ADDENDUM NO. 1

June 21, 2023

Renovations & Additions to Rockbridge Innovation Center

Project No. 21148
VA DOE PROJECT # 081-02-01-101

SHEET REF. NO.: E103L

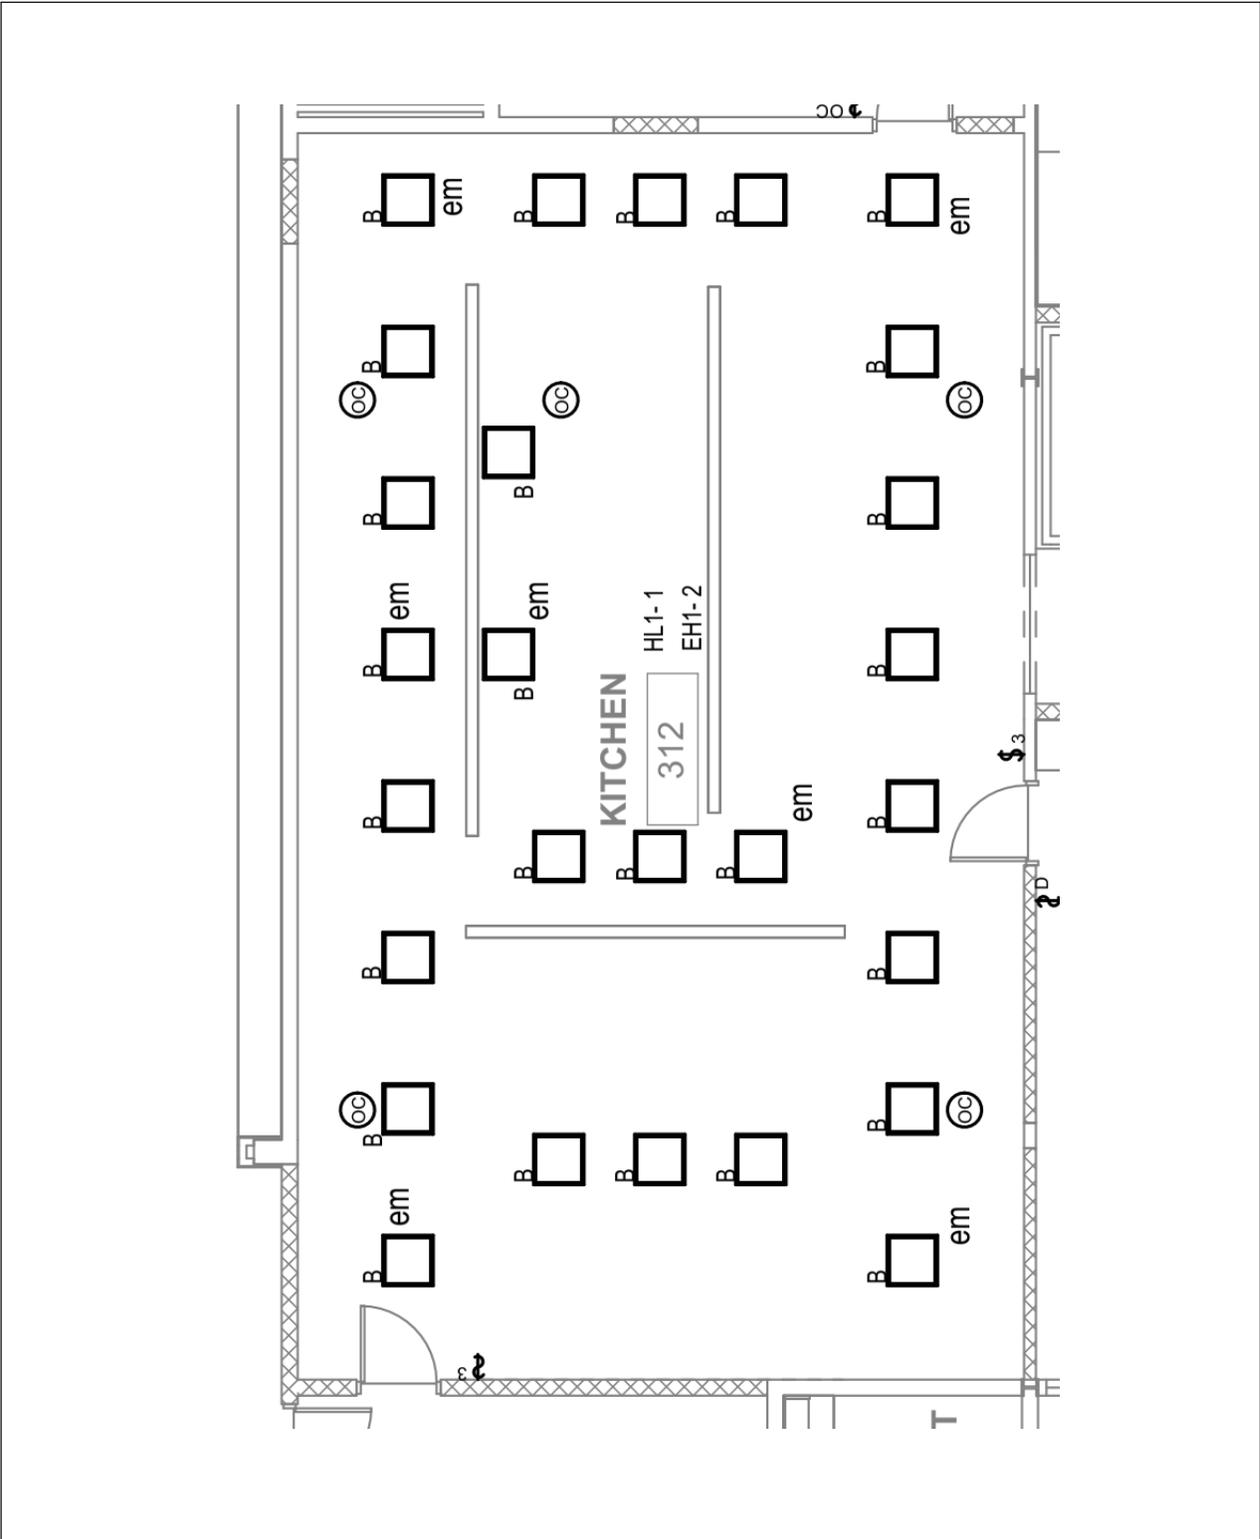
22. E103L – ELECTRICAL LIGHTING PLAN – AREA A, Revised lighting layout for KITCHEN room 312. See sketch E5.
